Subject: MHI's Responses to US-APWR DCD RAI No.681-5257 Revision 2 (SRP 19.0)

# Responses to Request for Additional Information No.681-5257 Revision 2

**US-APWR Design Certification**

RAI NO.:NO. 681-5257 REVISION 2SRP SECTION:19 – Probabilistic Risk Assessment and Severe Accident EvaluationAPPLICATION SECTION:19DATE OF RAI ISSUE:01/20/2011

Figure 19.495-1 RCS Water Level Transition

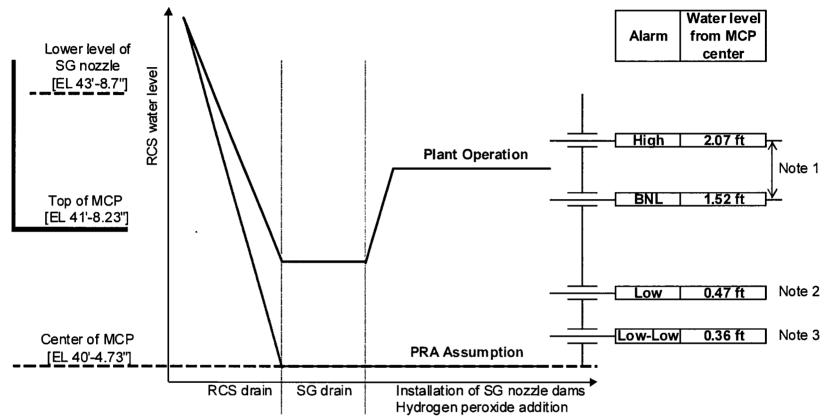
- (a) In order for the staff to evaluate the human error probability, MHI is requested to document in Chapter 19 and Section 5.4.7.2.3.6 of the DCD (1) the hot leg level/set point at which this automatic isolation is supposed to occur and (2) the highest hot leg level at which the RHR pumps are expected to fail due to air ingestion given a RHR flow rate of 2650 gpm required by TS surveillance testing.

- (b) In the last paragraph on page 5.4-45, it is stated that higher RCS level reduces the possibility of air entrainment during midloop, which is reported as approximately 4 inches above hot leg midplane. This increased margin to air entrainment has no basis since operating PWRs maintain RCS hotleg levels within inches to the level that vortexing initiates. Please remove this statement or please provide the analysis which documents the hotleg levels at which vortexing initiates and becomes fully developed for the highest flow rate anticipated for midloop operation.

Figure 19.495-1 shows the postulated images of RCS water level with water level for automatic isolation of low-pressure letdown line and for CS/RHR pump surveillance testing. The

automatic isolation for the low-pressure letdown line is initiated by detection of the RCS Low water level signal, which actuates when the RCS water level is below 0.47 feet above the loop center.

Also, TS surveillance testing for CS/RHR pump is performed when the RCS water level is between RCS Low water level (0.47 feet higher than loop center) and RCS High water level. (2.07 feet higher than loop center). The high SG installation elevation of the US-APWR design can keep RCS water level higher than loop center during SG maintenance and hydrogen peroxide operation. The design enables the RCS water level to be maintained higher than 0.33 feet above the loop center for all modes of RHR operation. RHR operation conducted under RCS water level higher than 0.33 feet above the loop center at 2,650 gpm does not cause air ingestion based on operating plant experience. CS/RHR pump surveillance testing with a flow rate of 2,650 gpm can be performed without air ingestion.
